**BHC/SAI Responses**

**Commercial Preliminary Development Plan  
Applicant's Letter**

**Application Number:** PL2022047

**Application Name:** K1 Speed

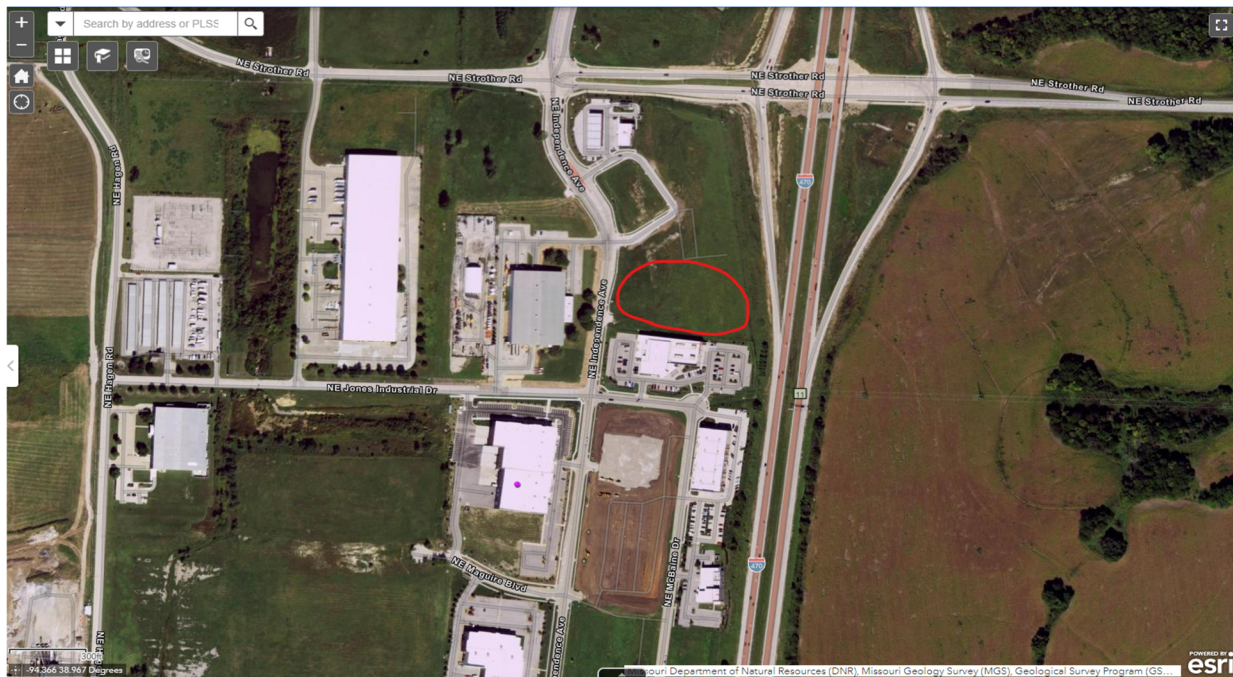
1. Please provide the location of all oil and gas wells, whether active, inactive, or capped. If none are present please add a note stating such and cite your source of information.

**Response:** See Image below. Sources were MO DNR – Aaron Szapa (Missouri Geological Surveyor). Also, the MO DNR arc GIS system was used. No wells are on our property. One is to our southwest under an existing building.
